WELLINGTON TRANSPORT MODELS

Addendum to TN19 : WPTM Calibration and Validation

Date: December 2012

Greater Wellington Regional Council

Figure 2-1: New Walk Links Added to Base Model

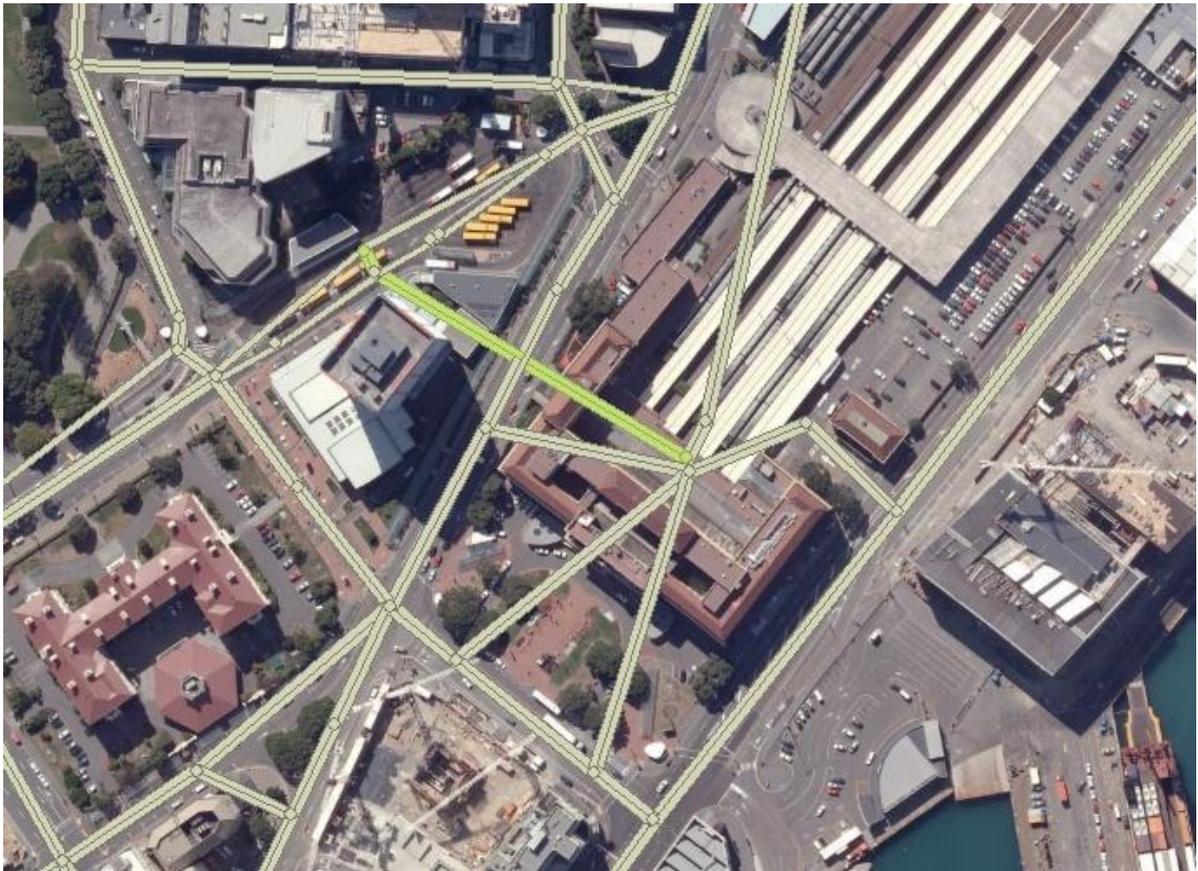
During model testing it was discovered that the walk tunnel between Wellington Station and the Lambton Quay bus interchange was not represented in the WTSM base network. This was added in to allow better representation of the routing options between these two points (see green links in Figure 2-1 below).

Figure 3-1*: AM Bus Screenlines by Direction

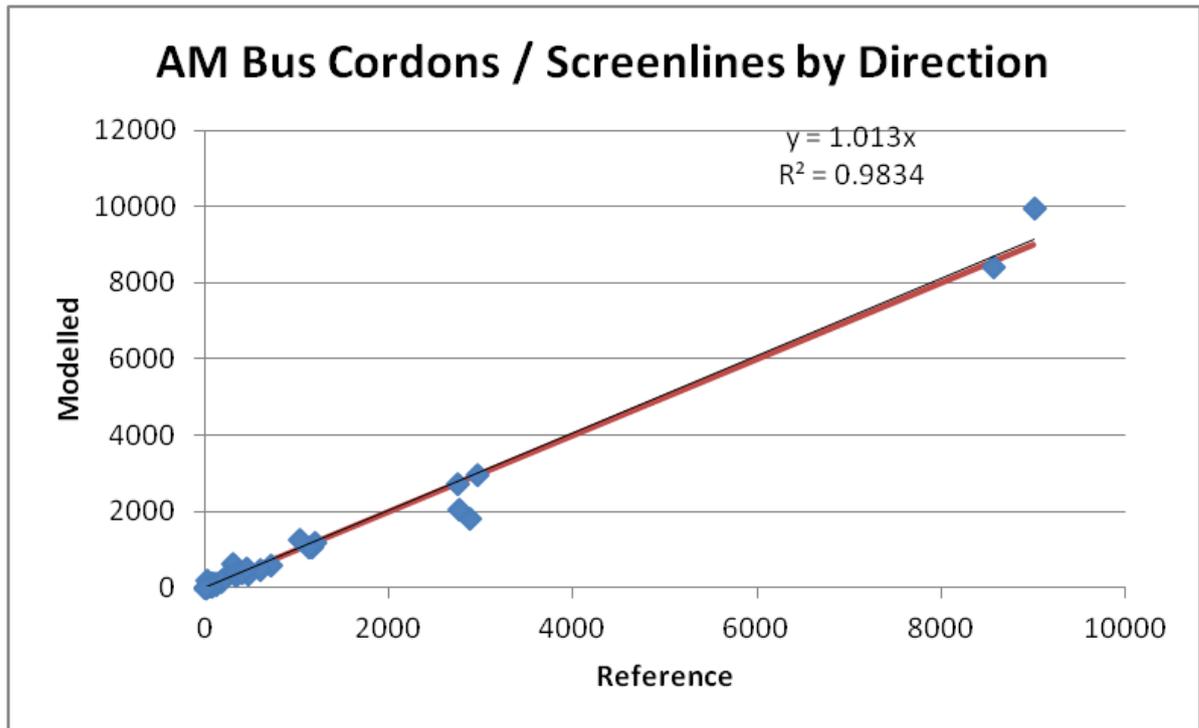
* This figure updates Figure 5-7 in TN19

Figure 3-2*: IP Bus Screenlines by Direction

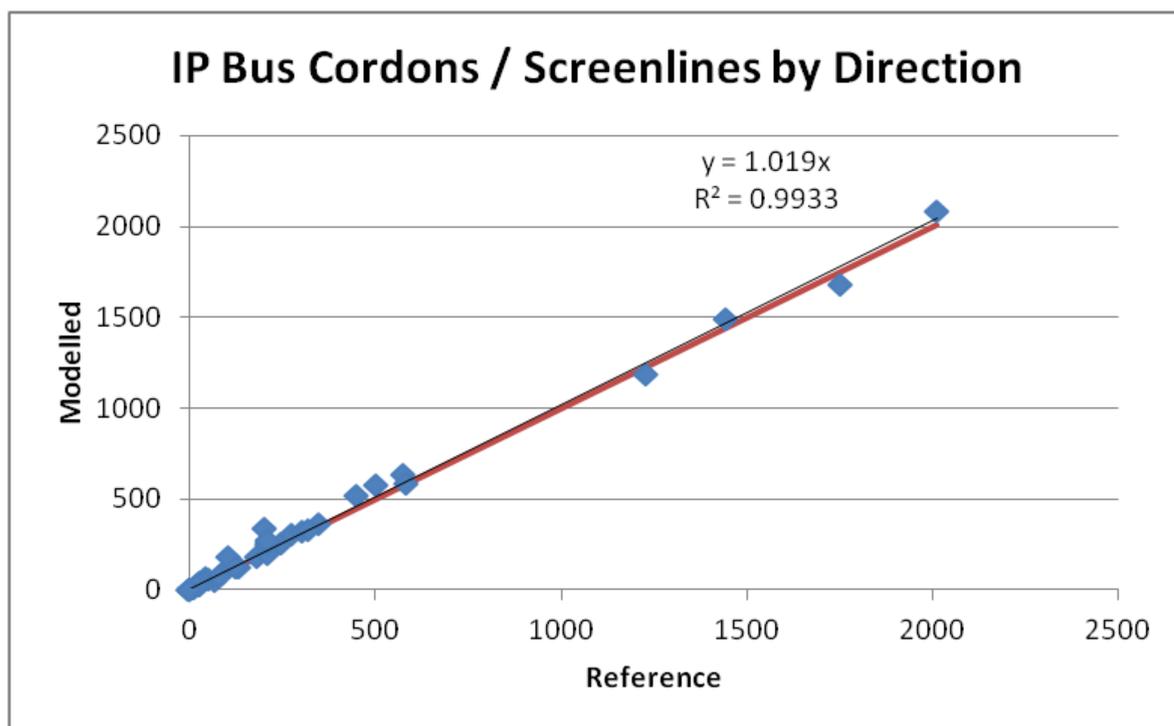
* This figure updates Figure 5-8 in TN19

Figure 3-3*: AM Rail Screenlines by Direction

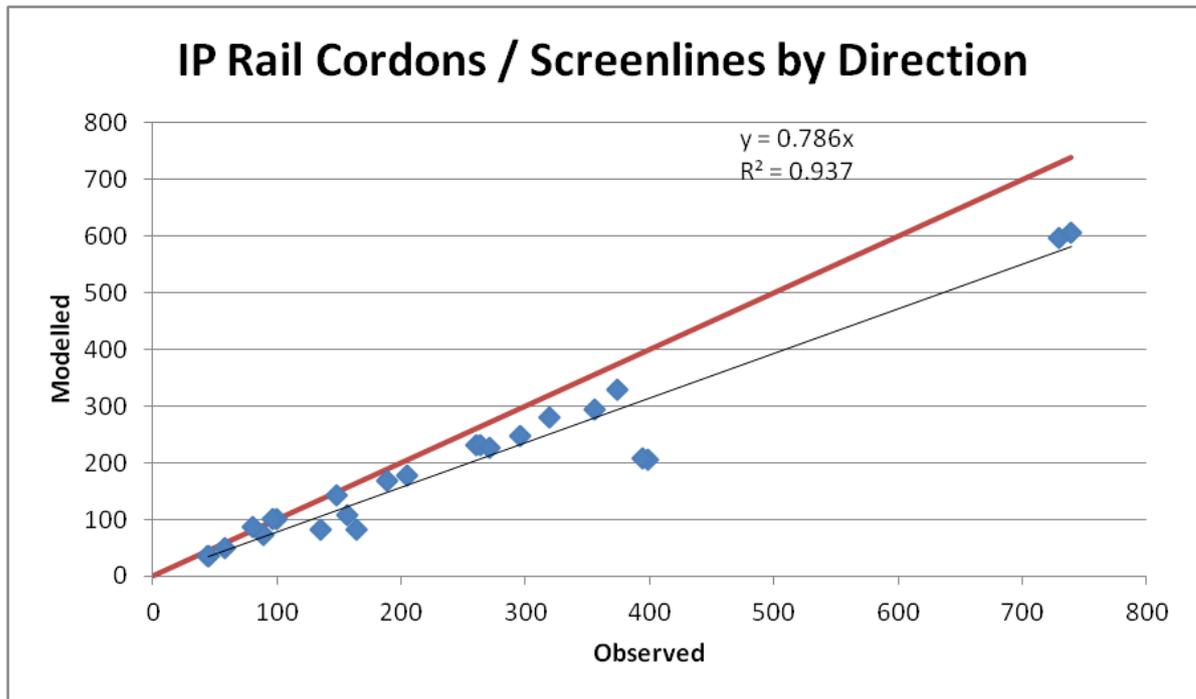
* This figure updates Figure 5-5 in TN19

Figure 3-4*: IP Rail Screenlines by Direction

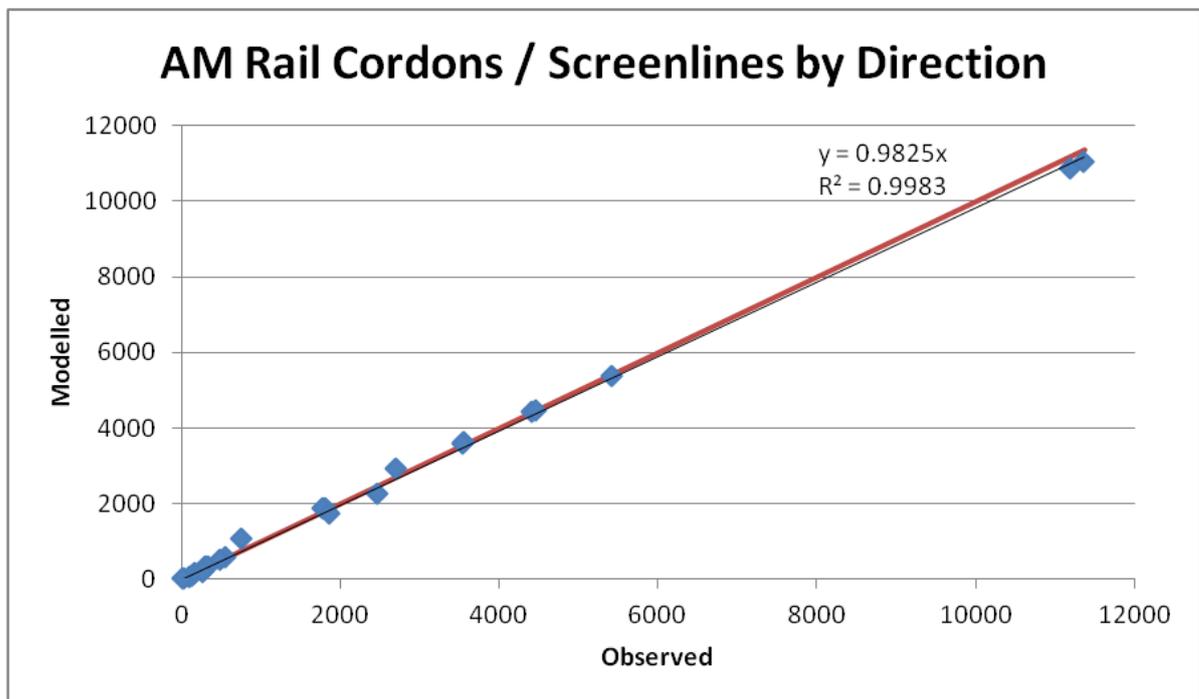
* This figure updates Figure 5-6 in TN19
